1 Products affected

Product hierarchy no. *			Part no.	SBU	Type / Description	Customer part no.
SBU	PG	PUG	Type			
02	007	013	0000002297	See list below	Connectors	4797 Appliance Outlet 16A 70°

Product Change Notification					PCN - 4797 Cord Retention Notches Added		
owner	creation date	release date	released by	change order no	rev	page	D10-034-720
vetersa	08.07.2019	14.08.2019	limachcl	2017298	B	1 of 2

Old product appearance	New product appearance
<p>Screw-on version</p>  	<p>Screw-on version</p>  
<p>Snap-in version</p> 	<p>Snap-in version</p>

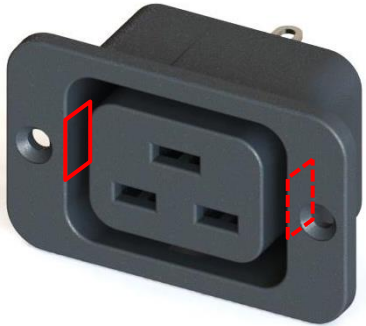
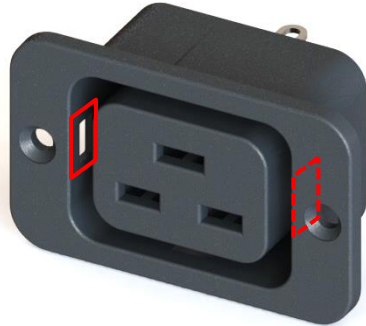
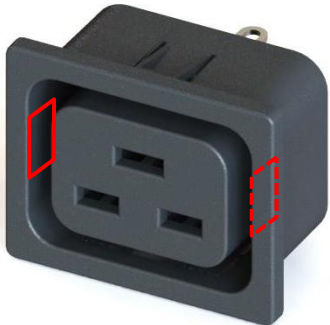
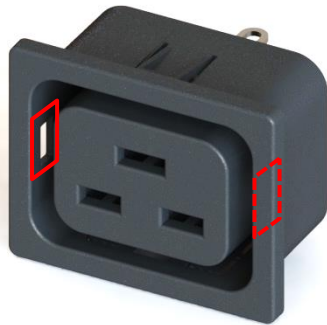
Two laterally positioned notches added to the molding body.

The notches are implemented as a standard feature to be compatible with side latching cord retention systems such as P-Lock, SecureLock or TwyLock.

Form	Yes	Laterally positioned notches. Fully backwards compatible
Fit	No	-
Function	Yes	Compatibility with side latching cord retention systems
Manufacturing	No	-
Label	No	-
Packaging	No	-
